# ***ADDENDUM TO WORK PLAN FOR CPT VERTICAL AND LATERAL STRATIGRAPHIC AND PLUME DEFINITION***

*76 Service Station No. 1871  
96 MacArthur Blvd  
Oakland, CA*

*Antea Group Project No. C101871705*

*July 8, 2011*

**FIGURE 2  
SITE PLAN**

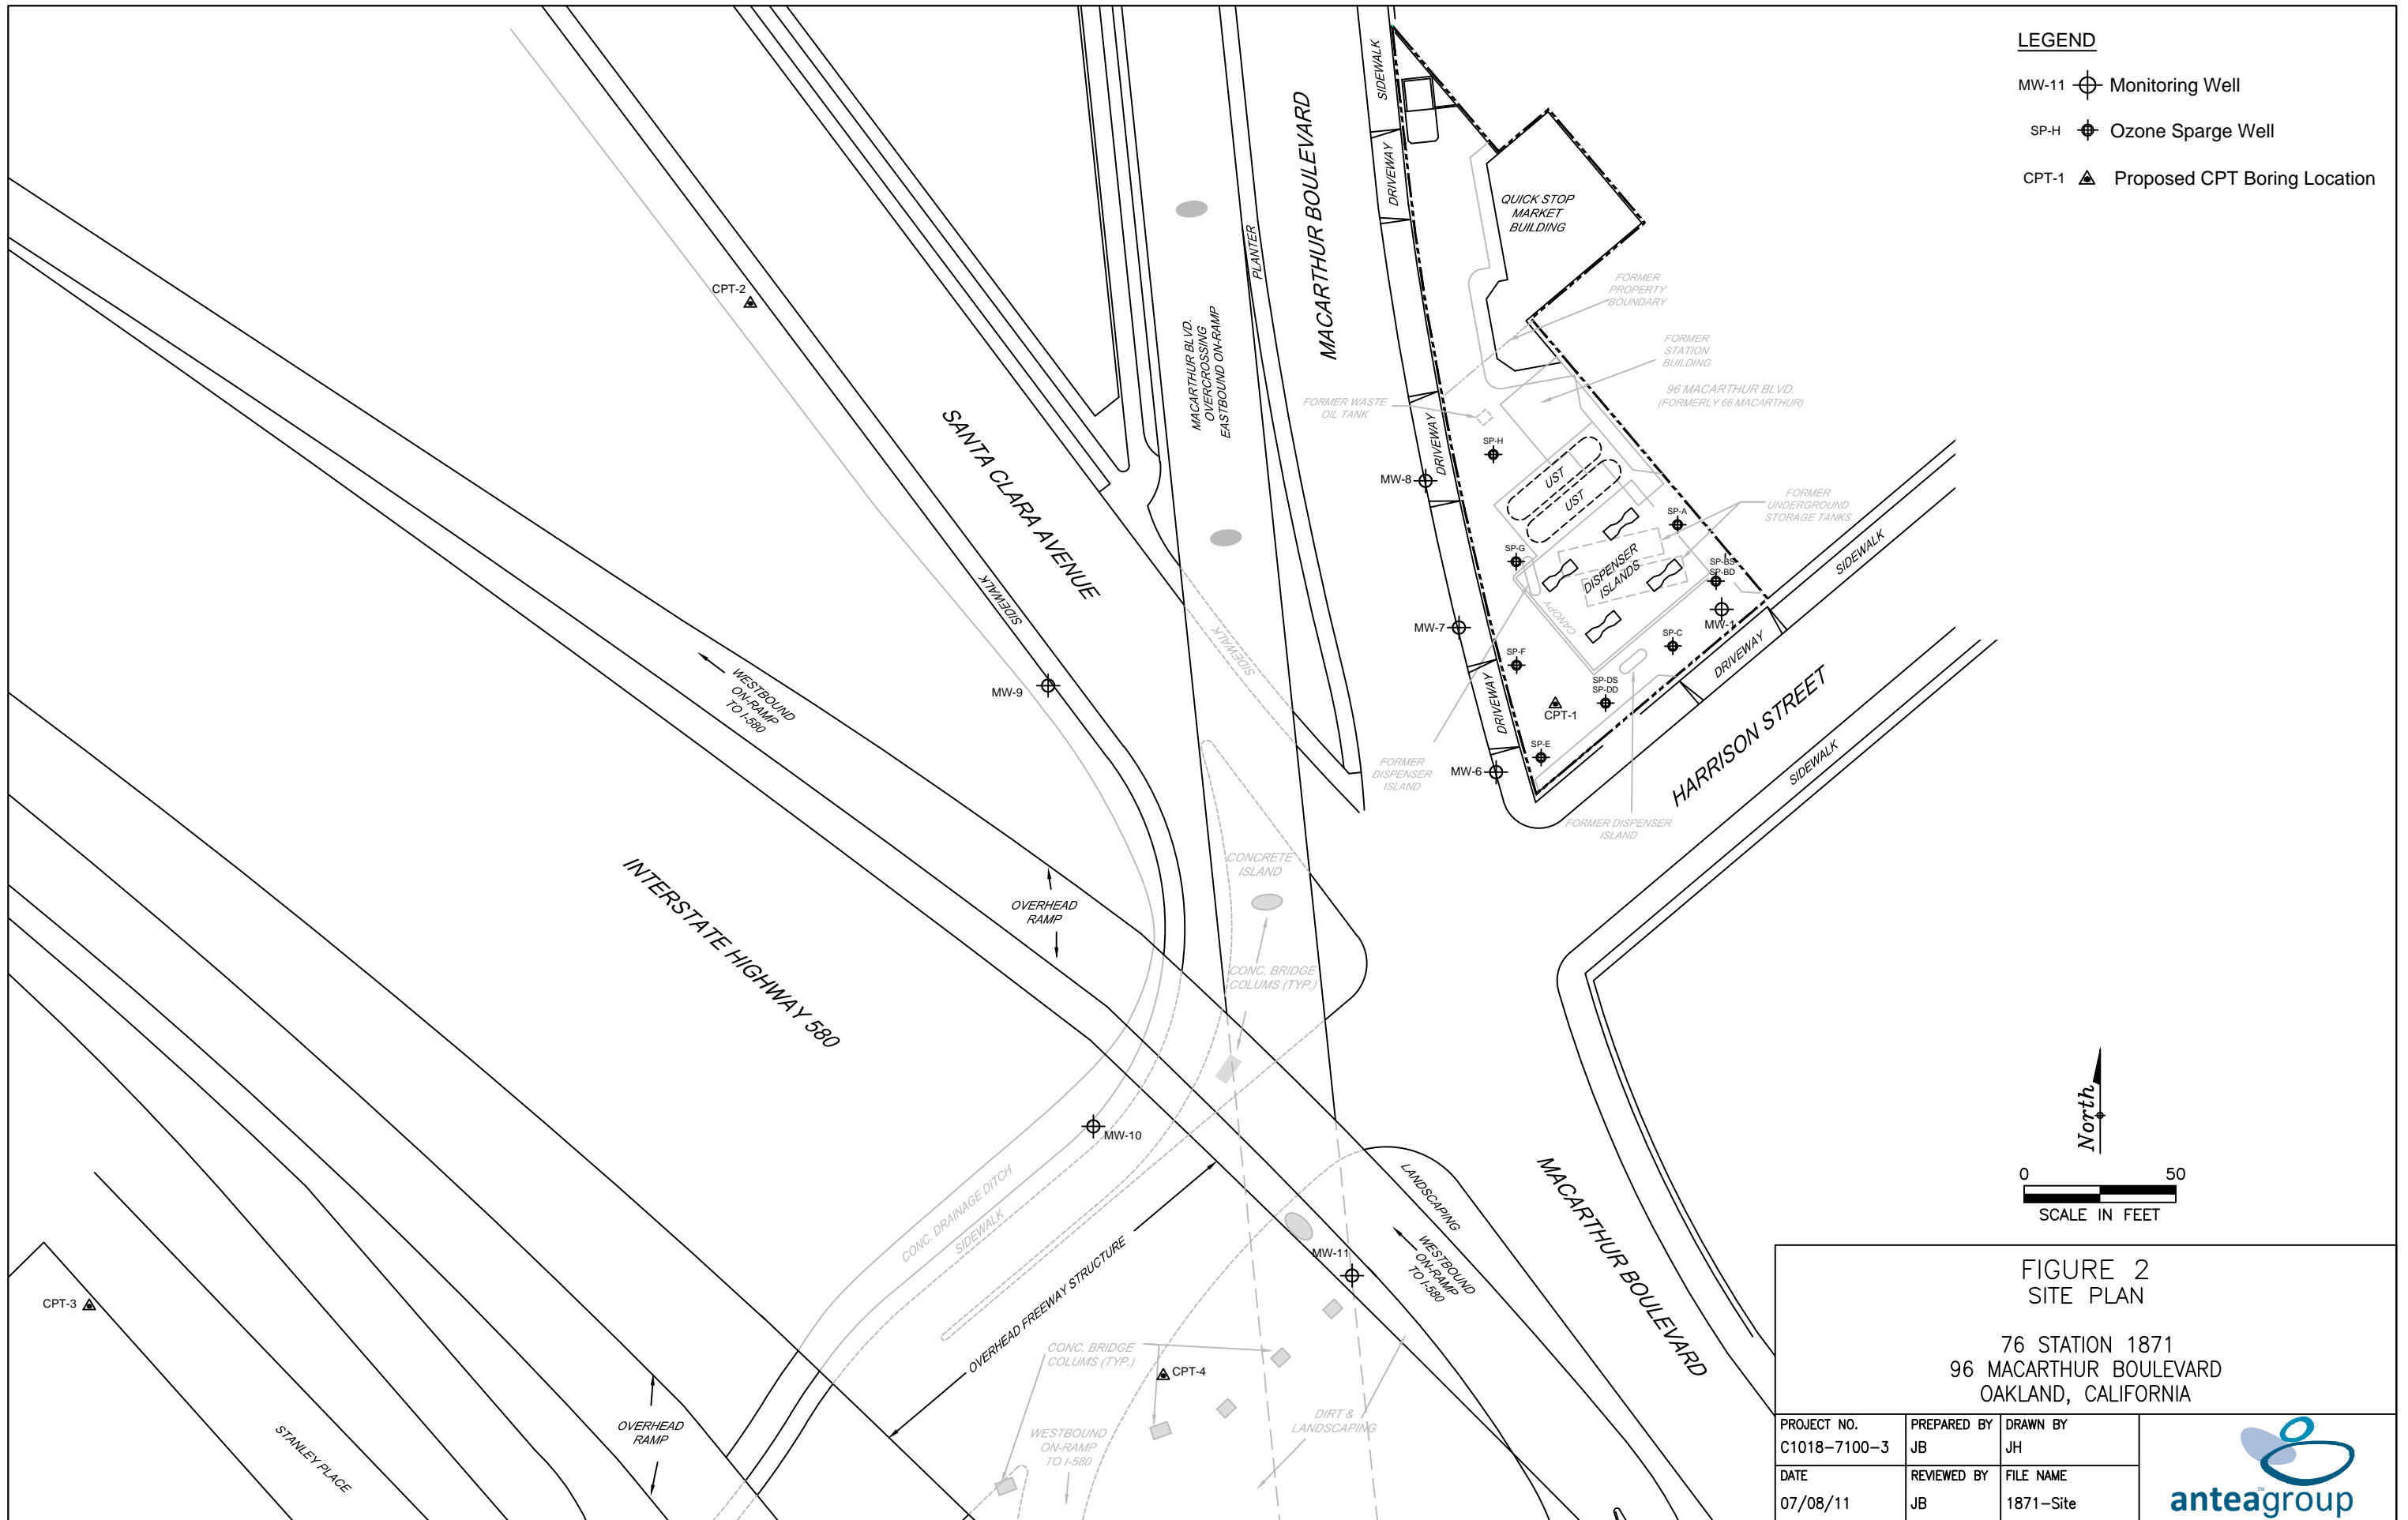
In response to your letter dated June 24, 2011 requesting an addendum to the Work Plan for CPT Vertical and Lateral Stratigraphic and Plume Definition (dated February 16, 2009), attached is the revised proposed CPT location map. The proposed locations have been changed from the original work plan based on the results of a wellhead survey performed in late 2010.
